Subject: Delray Beach CRA Purchase/Sale Agreement – 238 SW 14th Ave

The Boynton Beach Faith Based CDC (BBFB CDC) hereby requests the following changes to be made:

Delray Beach CRA Single Family Housing Project
238 SW 14th Avenue, Delray Beach
Additional and Revised Project Information

FIRST FLOOR FLOORING ZONES PLAN
FLOORING DESIGNATIONS

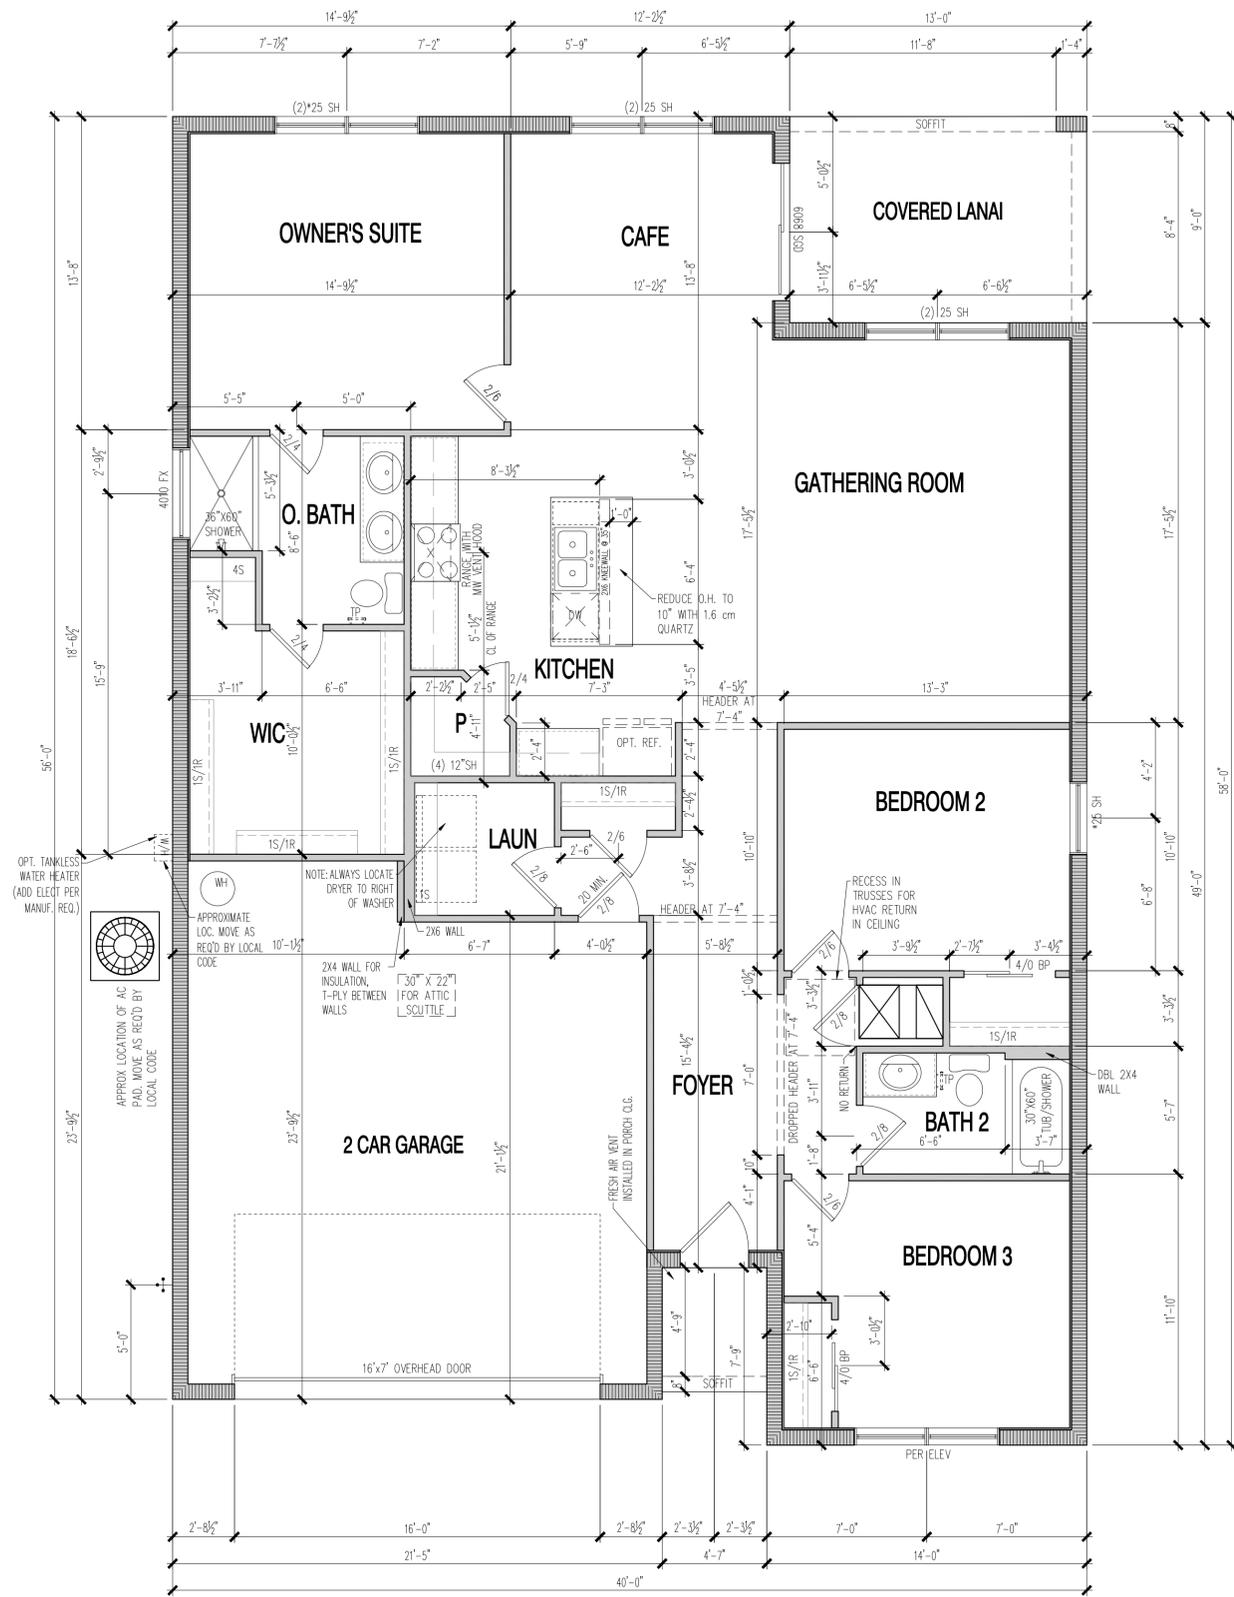
- **Floor Plan and Model Modifications:** The original three-bedroom, two-bath layout from Hatcher Construction to the Chapman three-bedroom, two-bath plan from Pulte. See attached copies of both floor plan options below.

- BBFB CDC confirms and attests that the new Chapman will meet all minimum requirements and specifications as stated within the RFP.
 - The air conditioned square footage was increased from 1,412 to 1,662 with the Chapman. The square footage of the garage also increased from 370 to 463.
